Platt Technical High School

ADDENDUM NO. 4

August 9, 2019

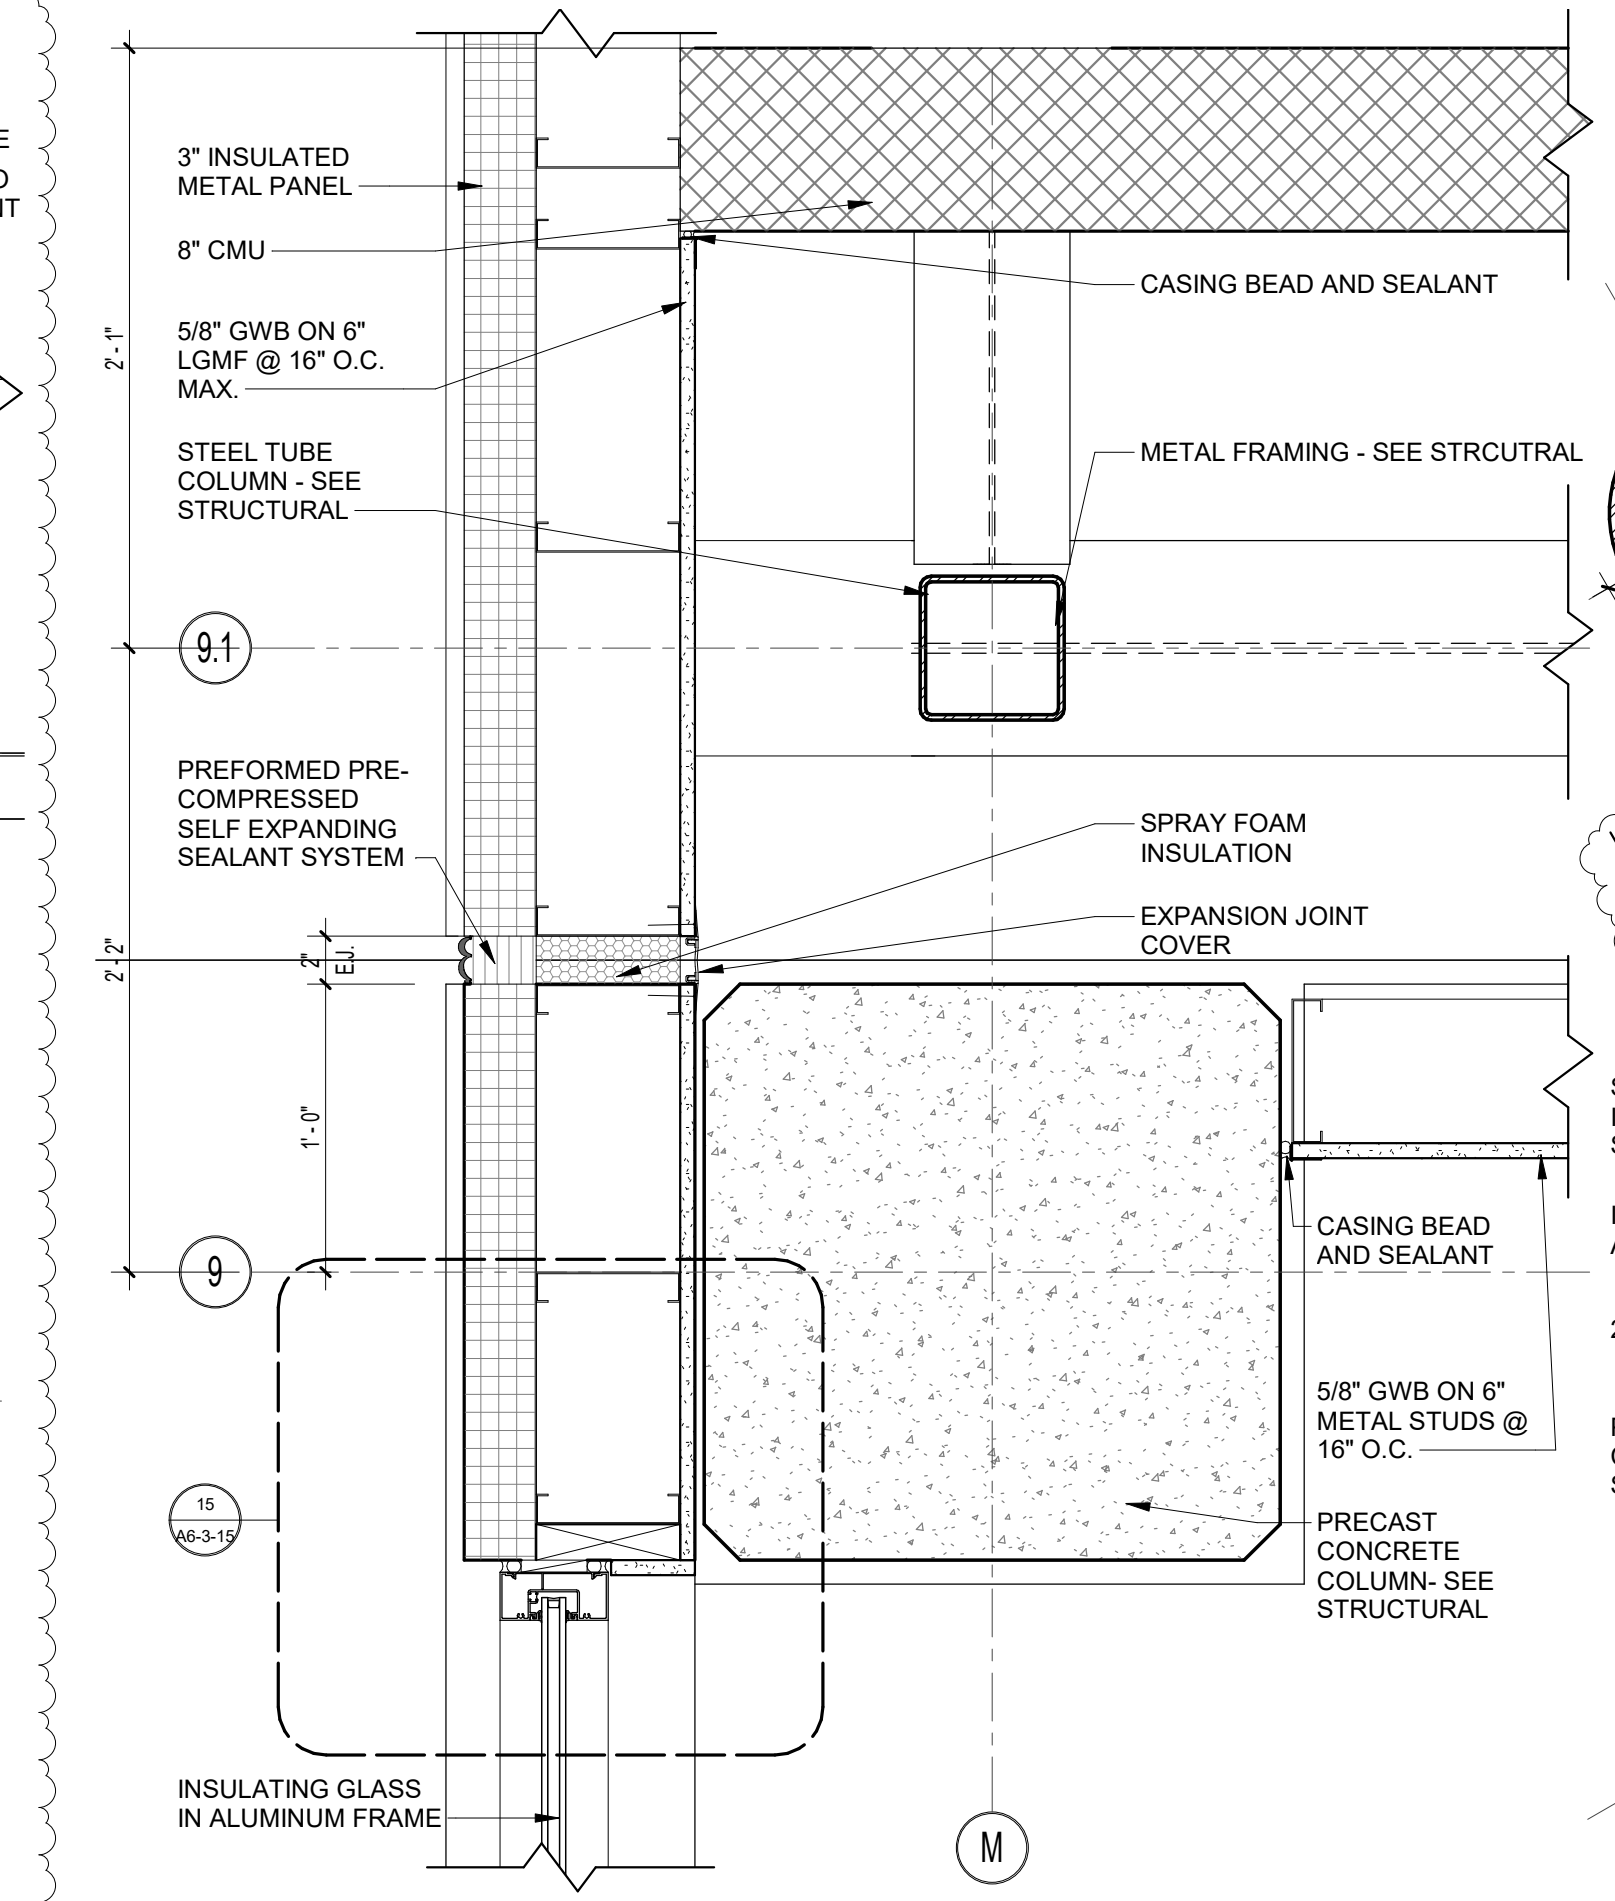
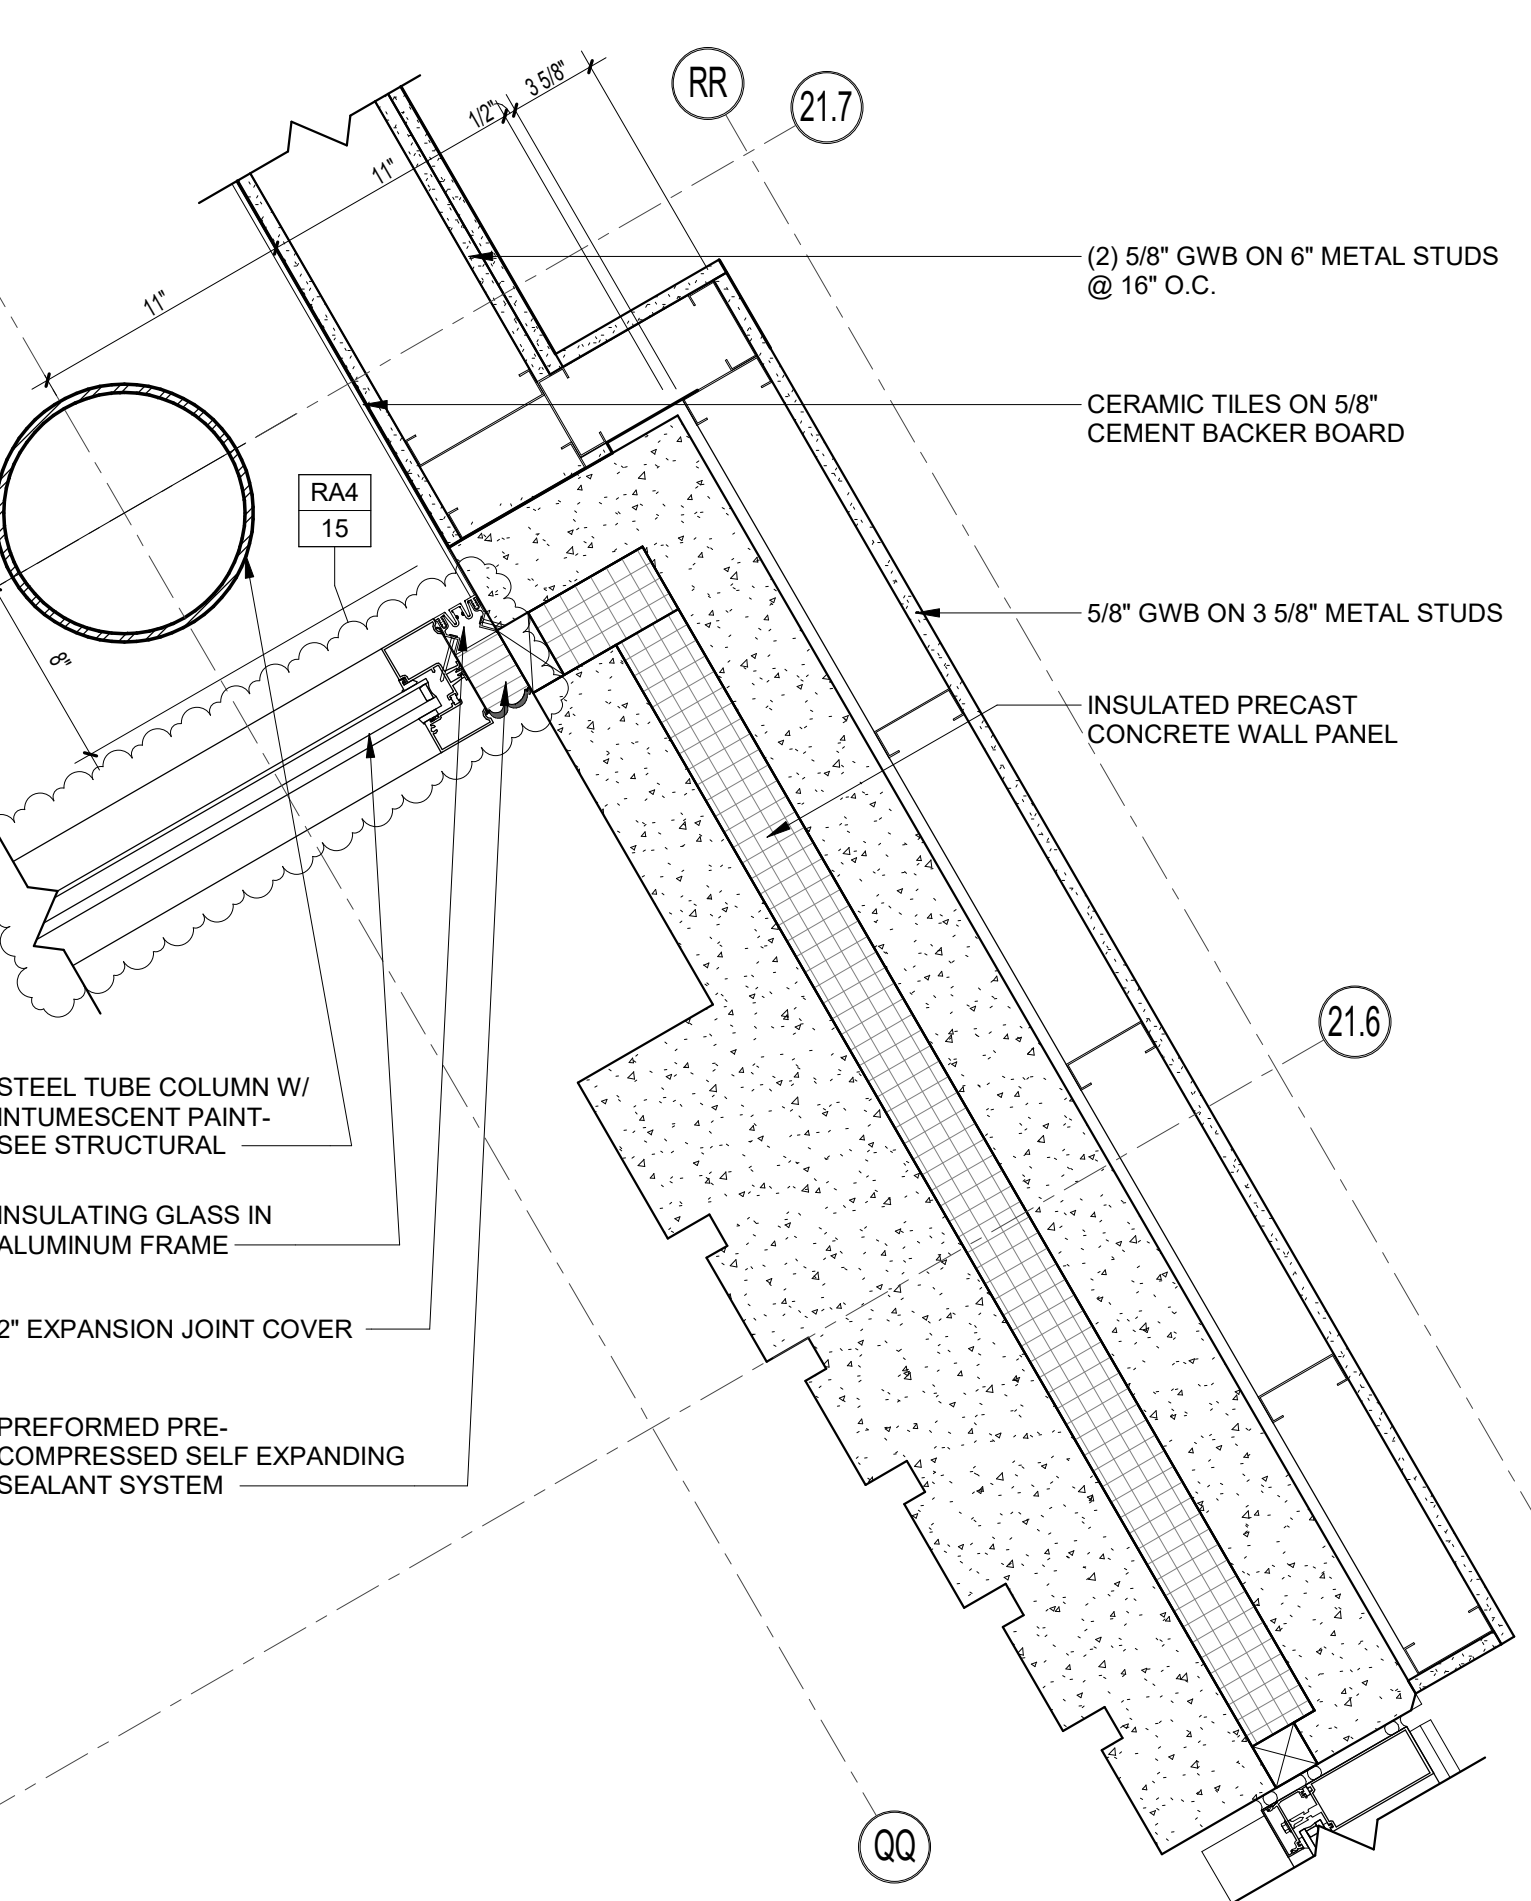
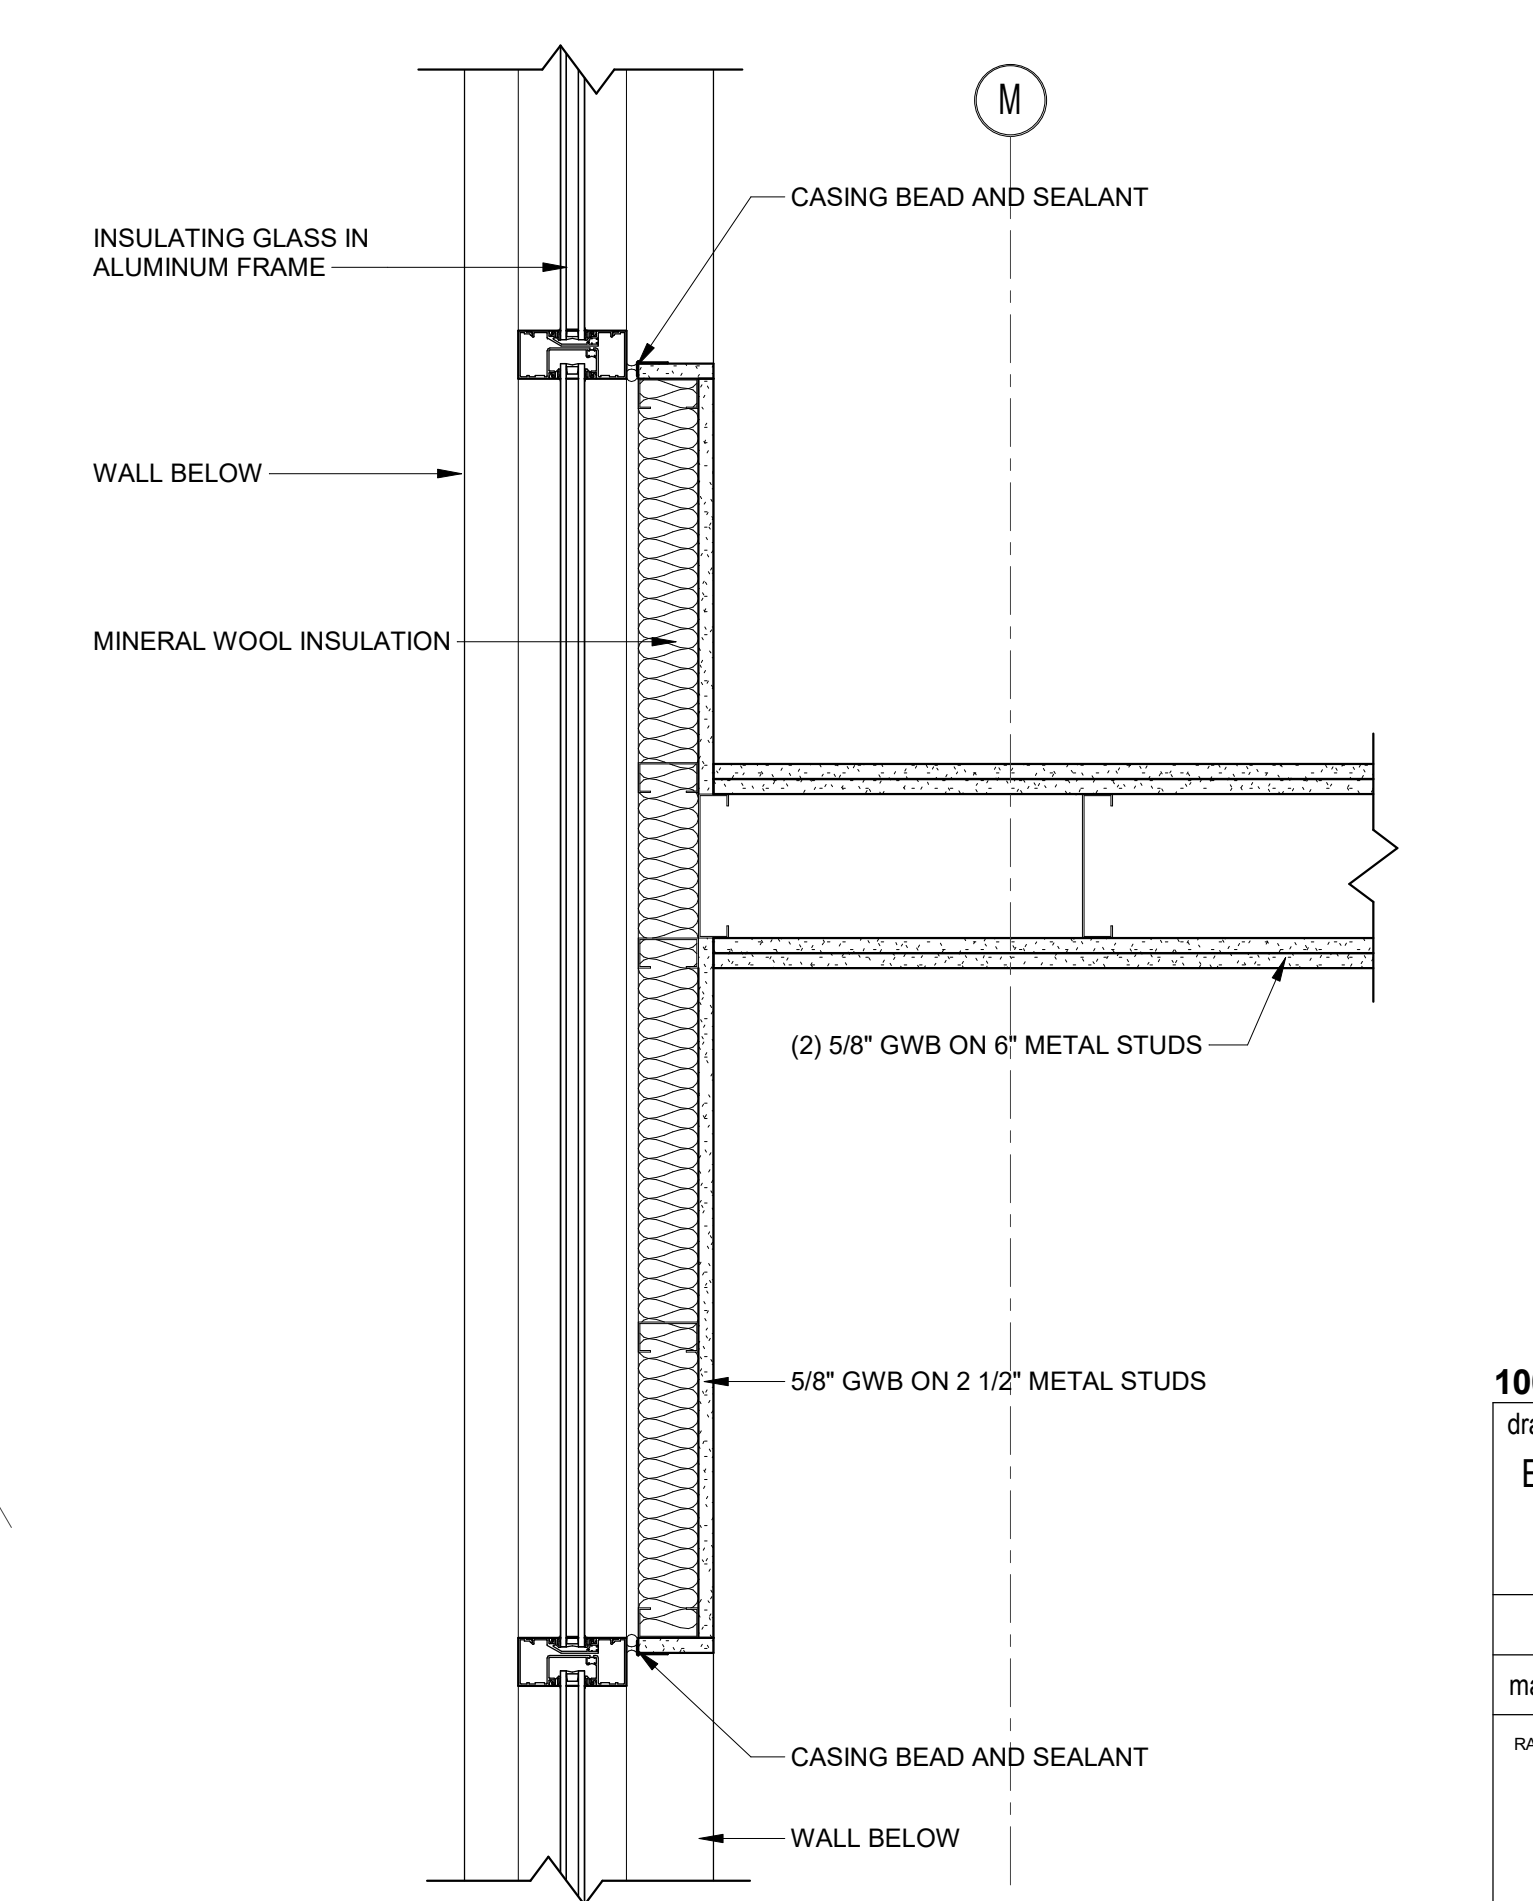
- ADD 4-094 A5-1-1 – EXTERIOR PLAN DETAILS**
Plan Detail 11: REVISED Aluminum Frame jamb detailing per Revision Sketch RA4-14.
- ADD 4-095 A5-1-4 – EXTERIOR PLAN DETAILS**
Details 4, 6, 9, & 10: Revised detailing per revision Tag RA4-15.
